## **TECHNICAL BULLETIN**

206L-17-254

SUBJECT: LINEAR ACTUATOR ELECTRICAL CONNECTOR

COVER DAMAGE LIMITS AND REPAIR

Figure 1 - Linear Actuator

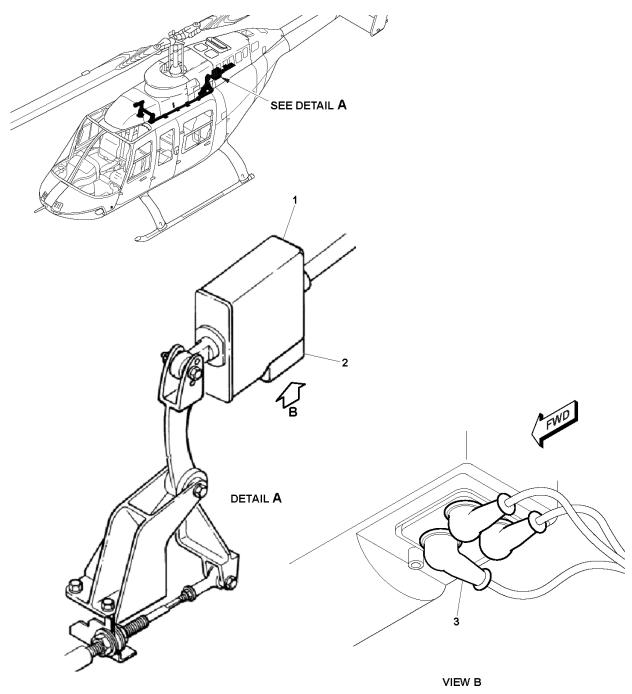
- 1. Prepare the helicopter for maintenance.
- 2. Inspect linear actuator connector cover (Figure 1, 2) for condition and security.
  - a. Cracks emanating from the attachment point screw area are not acceptable, and requires replacement of the connector cover (2).

- b. Cracks not emanating from the attachment point screw area are acceptable, however, must be stopped drilled to prevent propagation.
- c. Damage to the connector cover (2) that exposes the wire terminals is not acceptable, and requires replacement of the connector cover (2).

- d. Any other damage not affecting the security of attachment of the connector cover (2) or exposing the wire terminals are acceptable.
- 3. If a serviceable linear actuator connector cover (2) is not available as a replacement part, remove the cover (2) and install nipples 90-115-1 (3) on the three electrical connectors.

- a. Remove the cover and disconnect the actuator electrical terminals one at a time to prevent mixing the cables.
  - b. Install a protective nipple 90-115-1 (3) on each terminal.

- c. Reconnect terminals and move the protective nipple (3) into position over the attachment studs.
- 4. Make an entry in the helicopter logbook and historical service records indicating compliance with this Technical Bulletin.
